STAFF RECOMMENDATION
1201 Lillian Street
October 21, 2015

Application: Demolition, New construction-infill
District: Lockeland Springs-East End Neighborhood Conservation Zoning Overlay
Council District: 06
Map and Parcel Number: 08313012300
Applicant: John Root, Architect
Project Lead: Melissa Sajid, melissa.sajid@nashville.gov

Description of Project: The applicant is proposing to demolish a non-contributing structure and to construct a new one and one-half story house with attached parking.

Figure 2. The attached carport at the rear of 1113 Lillian Street is similar to this request.

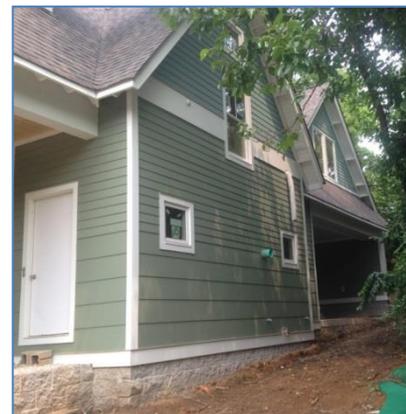
Outbuildings: The roof of the house will extend toward the rear with a gable over an open-sided parking area. Although attached garages and carports are not typical of the area, Staff finds it is appropriate in this case for a number of reasons. First, this block of Lillian does not have an alley at the rear, and the lots are significantly shallower than the majority of lots nearby. This lot is approximately fifty feet (50') shorter than the typical lot in the area. Consequently, the depth of the lot makes it difficult to locate a detached outbuilding at the rear of the lot, as recommended in the Design Guidelines. The parking area is underneath the primary roof and is unlikely to be greatly visible from the street as it is obscured by components that step out wider than the primary mass of the house. In addition, there is very little historic context present along this block of Lillian Street. The Commission

approved a similar attached carport at 1113 Lillian Street in January 2015 (Figure 2) and at 1115 Lillian Street in August 2015.

Staff finds that the proposed attached carport meets Section II.B.8. of the design guidelines.

EAST ELEVATION

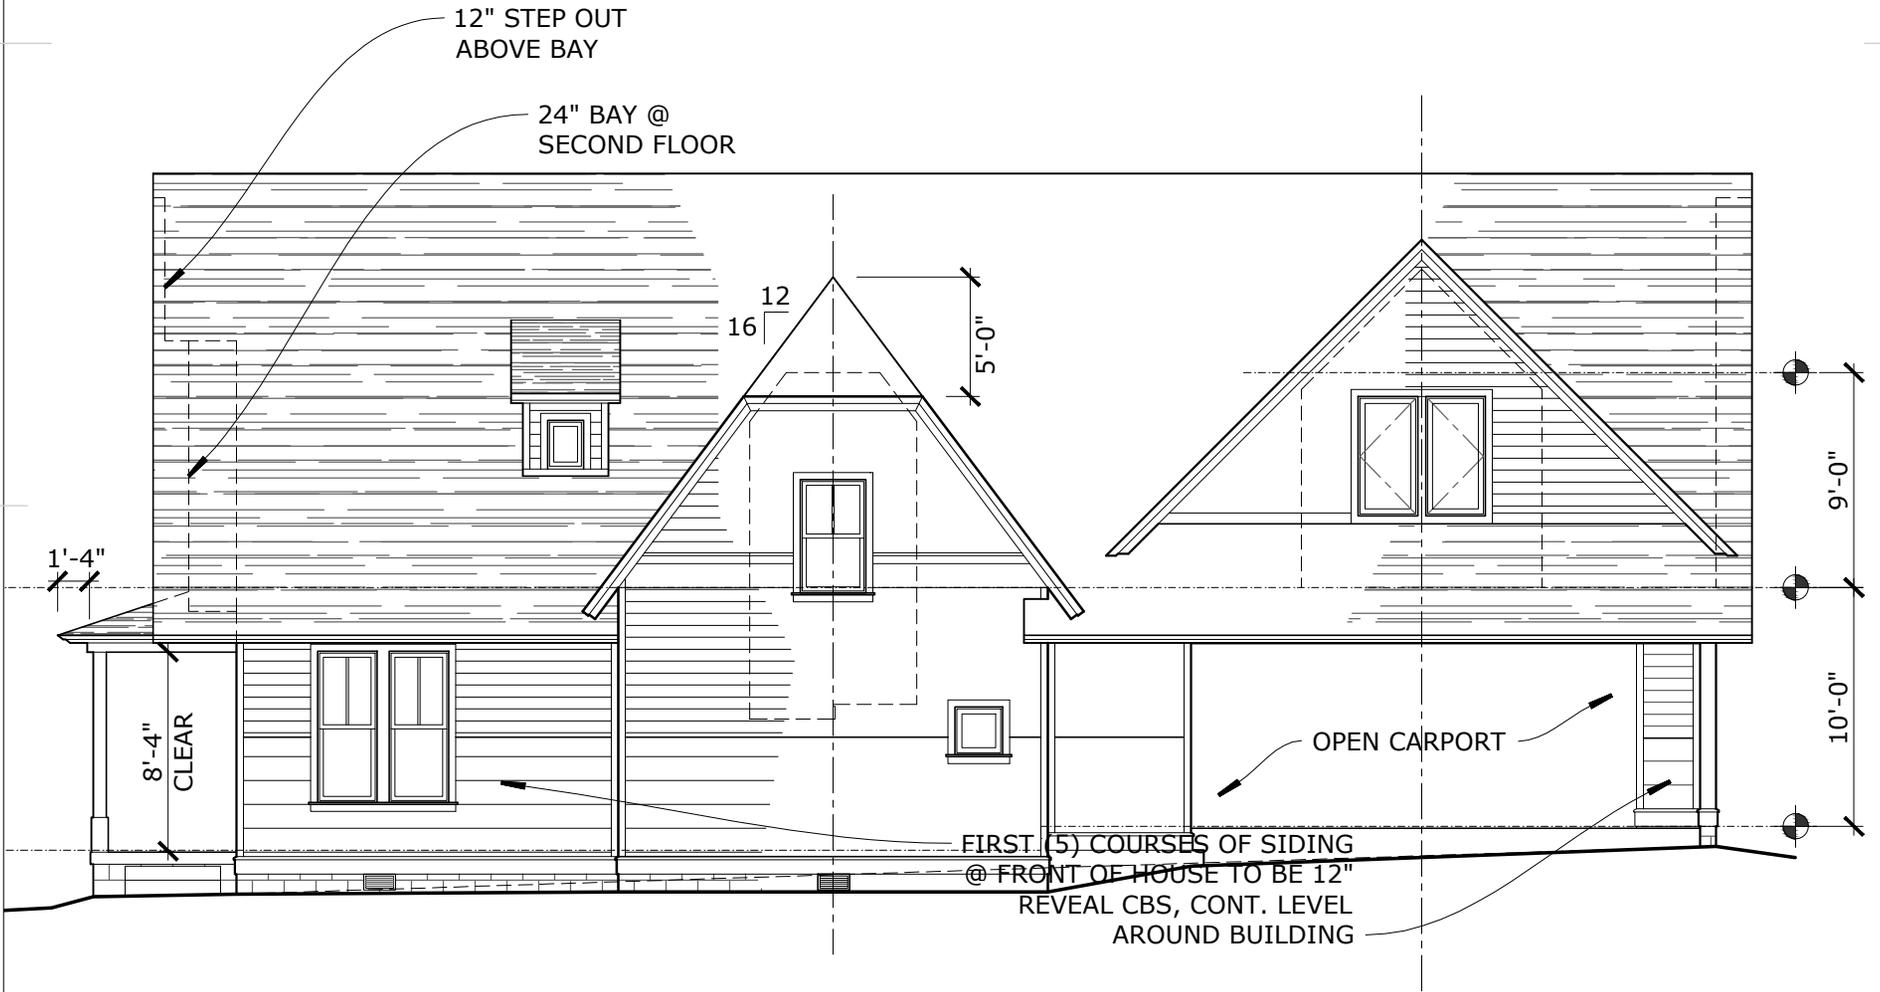
Materials: The exterior materials will include a split-faced concrete block foundation, smooth-faced cement-fiber siding, and an asphalt shingle roof. The front façade also incorporates a cedar shingle accent on the front gable. The color of the roof is not known. The siding will have a twelve inch (12") reveal on the lowest five courses, with the remaining majority of the siding having a five inch (5") reveal. Although a five inch (5") reveal is typically required, the Commission has approved greater reveals when used as an accent. The exterior trim, including cornerboards, window casings, and porch columns will be wood and cement-fiberboard. The porch floor is concrete. The windows will be primarily two-over-one simulated divided light Ultrex clad, which is a fiberglass material, and is appropriate. With a condition that the roof color and the final selections

WEST ELEVATION

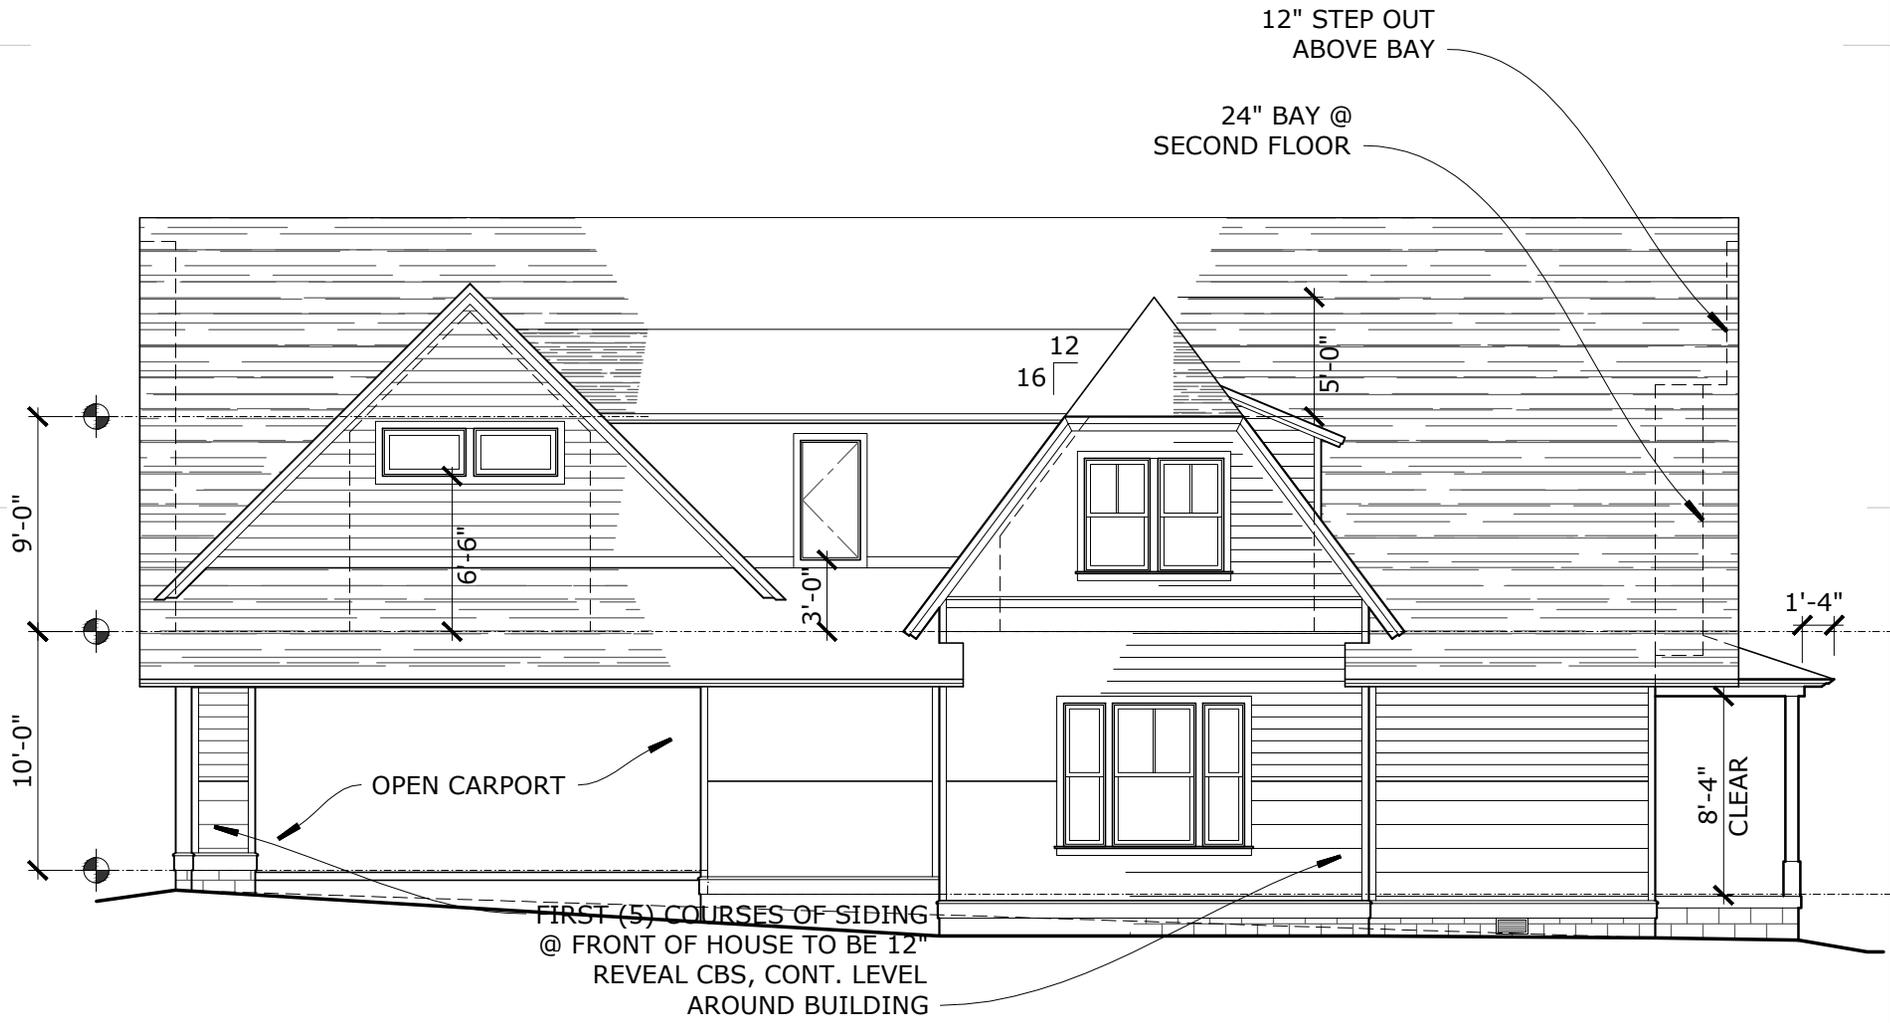
1. The finished floor height be consistent with the finished floor heights of the adjacent historic houses, to be verified by MHZC staff in the field;
2. Incorporate an additional window on the west façade near the front of the house so that there will be no expanse greater than eleven feet (11') without an opening on any of the primary elevations;
3. Staff approve the final details, dimensions and materials of windows and doors prior to purchase and installation;
4. The HVAC be located behind the house or on either side, beyond the mid-point of the house; and
5. Staff approve the roof color, dimensions and texture.
